AGENDA
TOWN OF RICO BOARD OF TRUSTEES
2 Commercial Street– Rico Town Hall
November 16th, 2022
7:00 PM

During the last month's planning meeting the commission continued the hearing of the Dolores River Trail subdivision to allow for a site walk and additional time for Mountain Civil Engineering to provide a response to comments submitted by the National Forest and Town of Rico's contract engineer, Alpine Land Consulting. A site walk was conducted on October 26, 2022. Mountain Civil Engineering submitted

revised plans and a memo addressing the comments provided by the Nation Forest and Alpine Land Consulting on November 2, 2022. The planning commission conducted a public hearing on November 9, 2022 and recommended approval of the preliminary plat with conditions. The draft minutes are included in the packet.

**DOLORES RIVER SUBDIVISION
ACCESS AND UTILITY
PLAN AND PROFILE
TOWN OF RICO, CO**

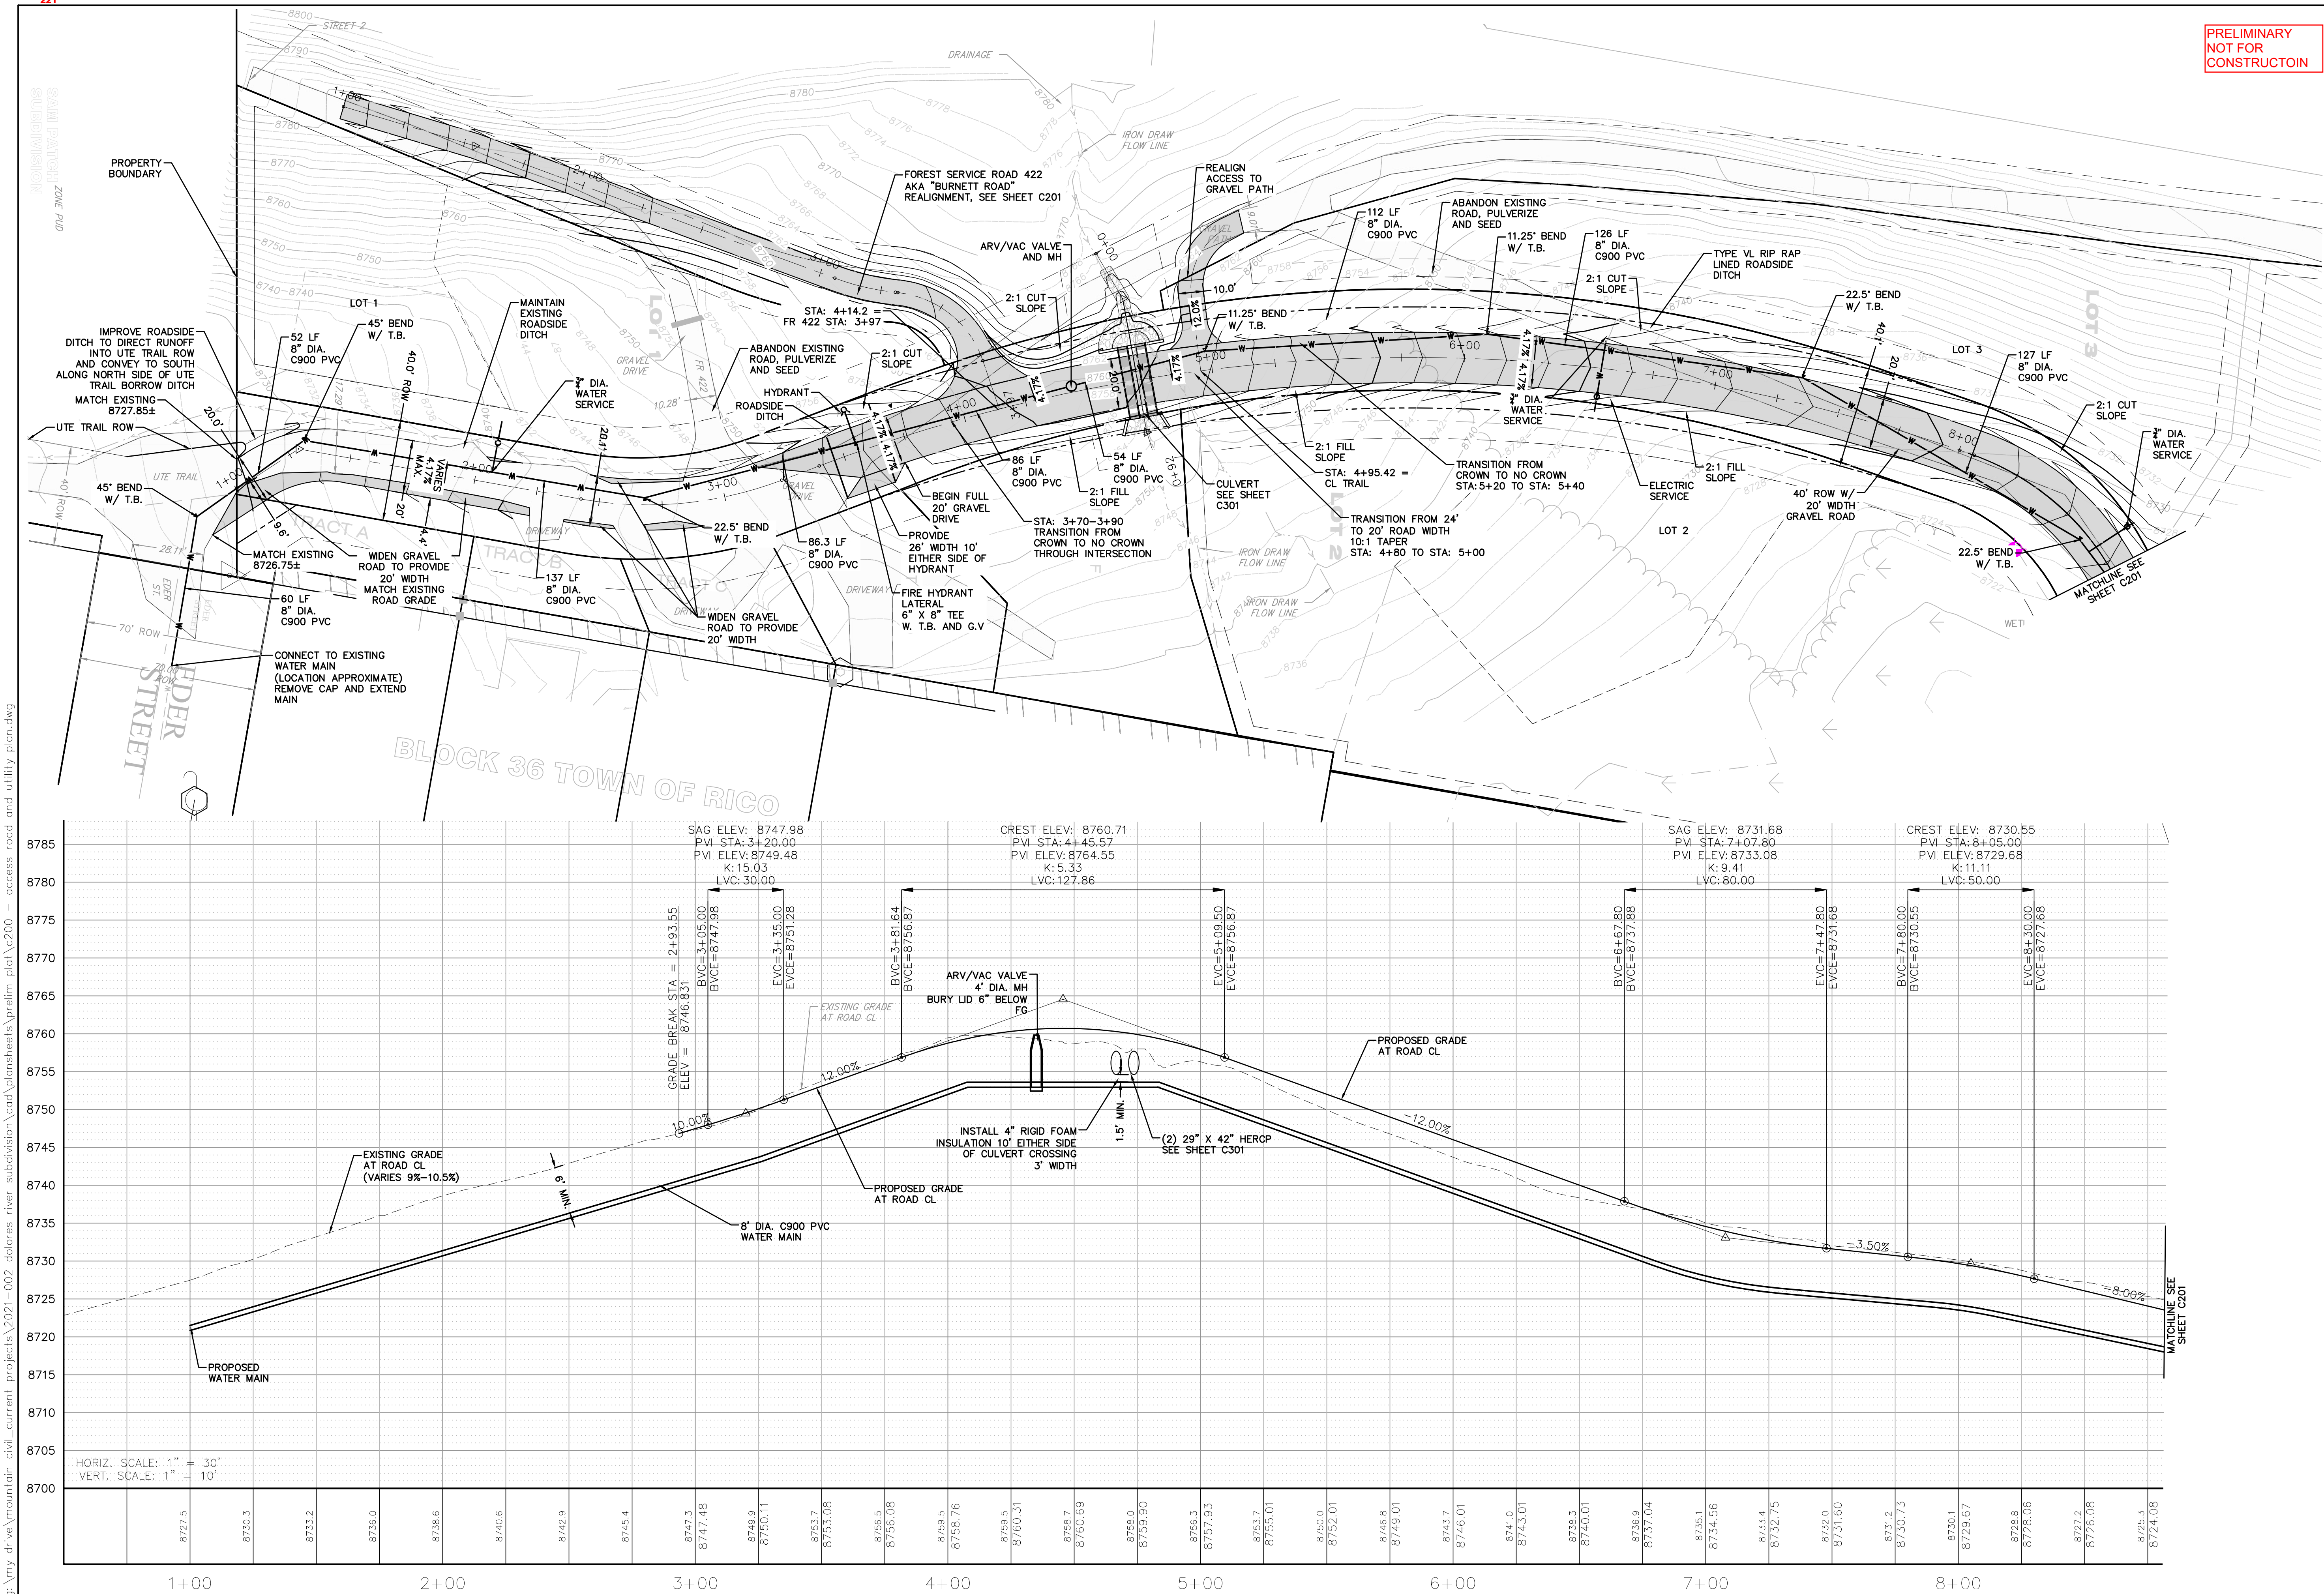
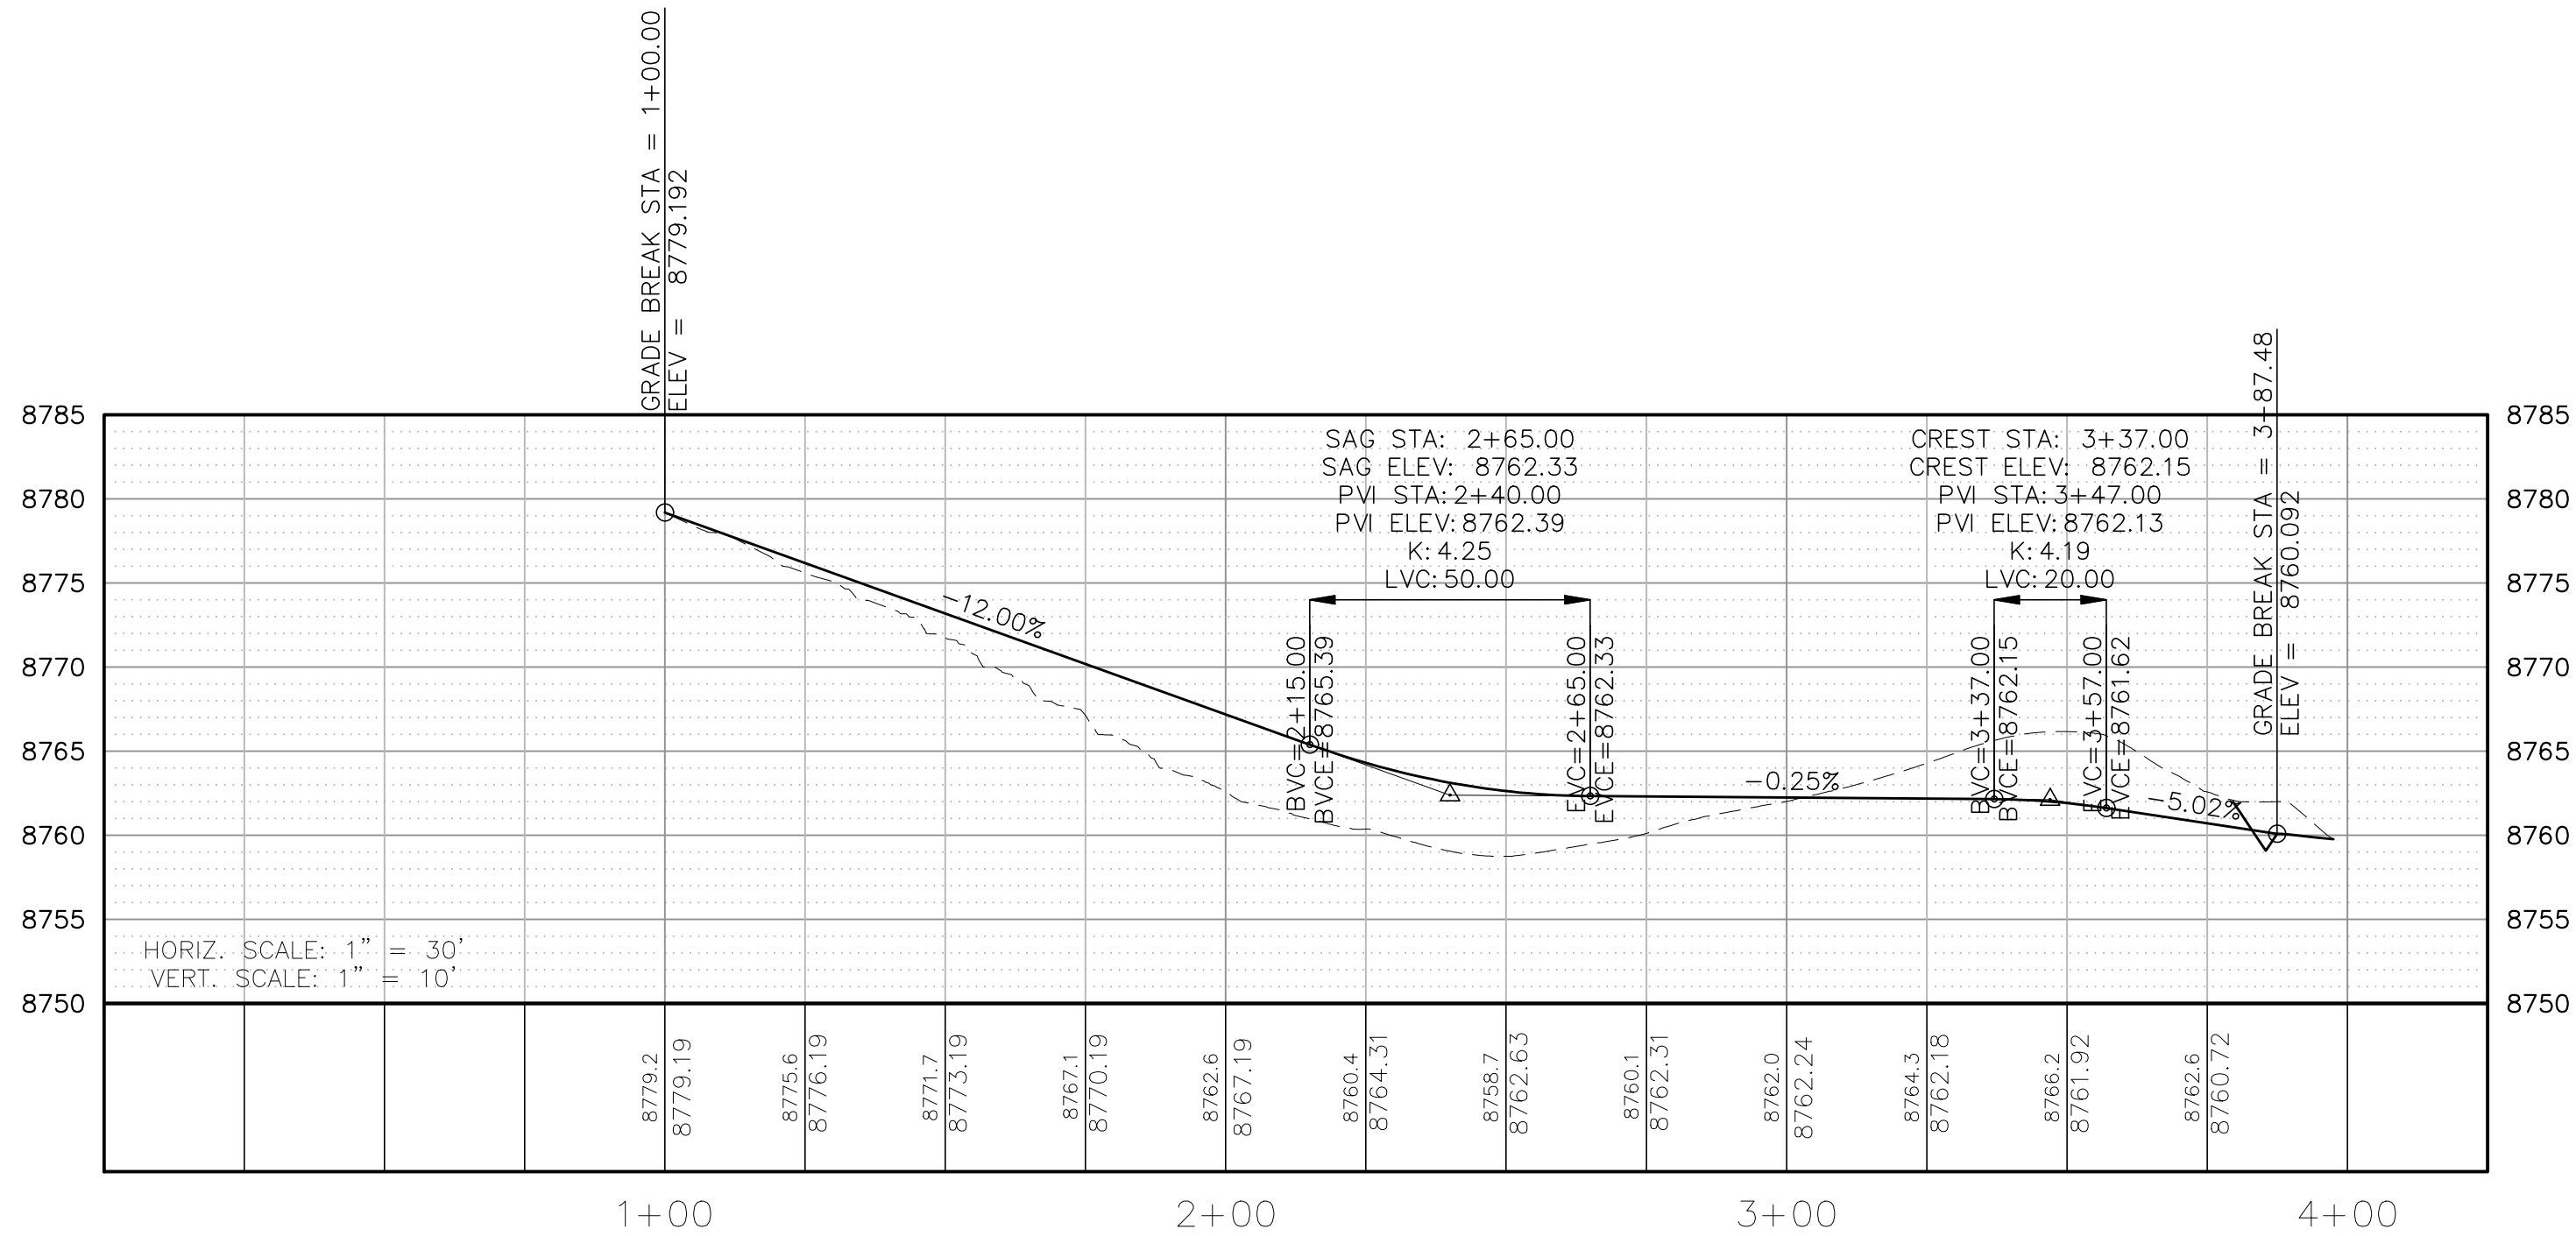
Sheet 5: It appears that the intent is to out slope the new alignment of 422 (indicated by the arrow and 2%). This seems like a risk given the new finished grade of 12% from station 1+00 to approximately 2+00. In addition, I believe the existing road beyond 1+00 continues at a steep grade. The risk I see is that the out slope will likely divert water off the newly constructed fill slope at the transition from 12% to 3% which appears to be approximately 7 feet of fill and on to the private property. The drawings do indicate a roadside ditch on the cut-slope side and it may be more appropriate to in-slope the road to this ditch. This would be the construction approach by the FS.

Sheet 5: The detail appears to indicate armored road side ditch from approximately 3+25 to 4+00 I am not clear on the intention of this design element but from a maintenance perspective the Forest Service would prefer to have the ditch remain native material.

6. Typical section for FR 422 has been added to sheet C400, including note on lift of fill material. All road work shall be constructed per Town of Rico or CDOT Standard Specifications for Road and Bridge Construction, including placing of embankment material.
